What is an Interlake Tunnel and What Does it Mean for You?

NACEMENTO REGIONAL WATER
MANAGEMENT ADVISORY COMMITTEE

INTERLAKE TUNNEL PROJECT Technical Memorandum

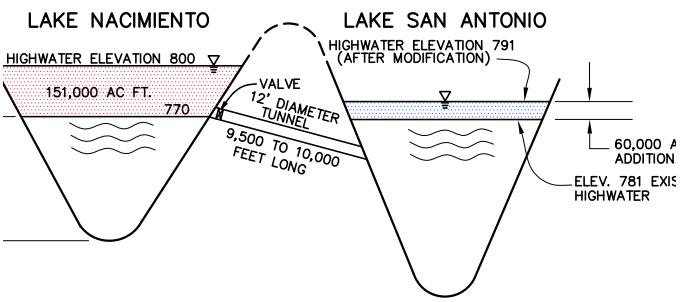
What design requirements or thoughts drive the size, location, elevation, shape, of the tunnel, the inlet and outlet works?

1. Location of the inverts (tunnel inlet and exit)?
2. Elevation of the inverts?
3. Size of the tunnel?
4. Size and Shape of other features?

Is there a prescription or rule for the transfer of water from one lake to the other?

Any information on timing, amount of transfer, flow rate, or other parameters?

What logic was used to model the flows between the lakes?

NRWMAC PREFERRED OPTION

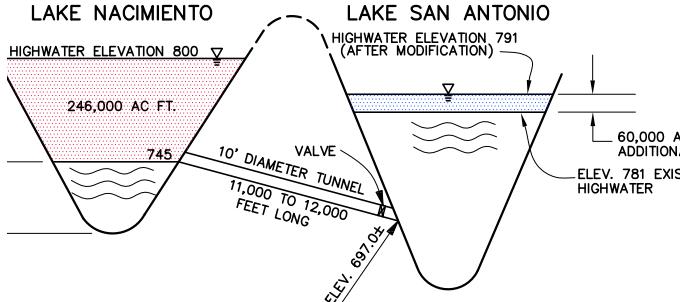
A concern of NRWMAC is why would MCWRA want the tunnel so deep? If the objective is to capture the 27,000 to 35,000 acre feet of potential annual spill, it can be accomplished with the tunnel at the higher elevation. There appears to be no reason for transferring water to San Antonio when Nacimiento is only at 35% capacity (elevation 745).

Operationally, an agreement needs to be in place that clearly outlines the rules of operation of the lakes after the tunnel is installed. NRWMAC must be certain that new operational rules protect Nacimiento from unnecessary transfers.
